Inland Transport Committee

Working Party on the Transport of Dangerous Goods

**Proposals for amendments to annexes A and B of ADR:
miscellaneous proposals**

Report of the informal working group on the electrical system of vehicles carrying dangerous goods

9.2.2.2.2 Additional protection

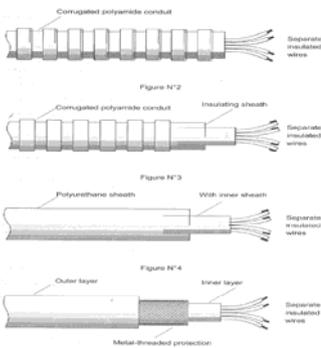
On heavy goods vehicles the wiring behind the driver's cab is more exposed to the elements. The risk for damage due to impact of road debris is more likely. Being only applicable to EX/III and FL the background was discussed. Where a flammable mixture could be envisaged for FL, this is not very likely for explosive substances and articles. Having an explosive atmosphere near the wiring on a moving vehicle and the absence of an explosive atmosphere for EX/III, it was felt that the common factor was reliability and development of fire of the vehicle. As this should also be prevented for the other vehicle categories it was suggested to extend this requirement to all categories.

Extending the application to other vehicle categories than FL and EX/III is expected to create limited extra costs as most manufacturers already have the FL/EX/III type of wiring for all vehicle categories, carrying two types of ADR wiring will increase costs.

An exception is the application for mass produced panel vans of which only a small percentage is used as ADR vehicle of EX/II category. Most panel vans have the wiring inside the bodywork where it is protected. For consistency it is proposed to extend the additional protection to EX/II vehicles, in case they are heavy goods vehicles with sheeted loading platforms and exempting for light panel vans.

Cables located to the rear of the driver's cab and on trailers shall be additionally protected to minimize any unintended ignition or short-circuit in the event of an impact or deformation.

*The additional protection shall be suitable for the conditions during normal use of the vehicle.
The additional protection is complied with if multicore cable is used in compliance to ISO 14572:2011 or one of the examples in figures 1 to 4 below or another configuration that offers equally effective protection.*

Cables of wheel speed sensors do not need additional protection.

. One stage built panel vans of the vehicle category EX/II where the wiring behind the drivers cab is protected by the body need not to comply with this requirement.
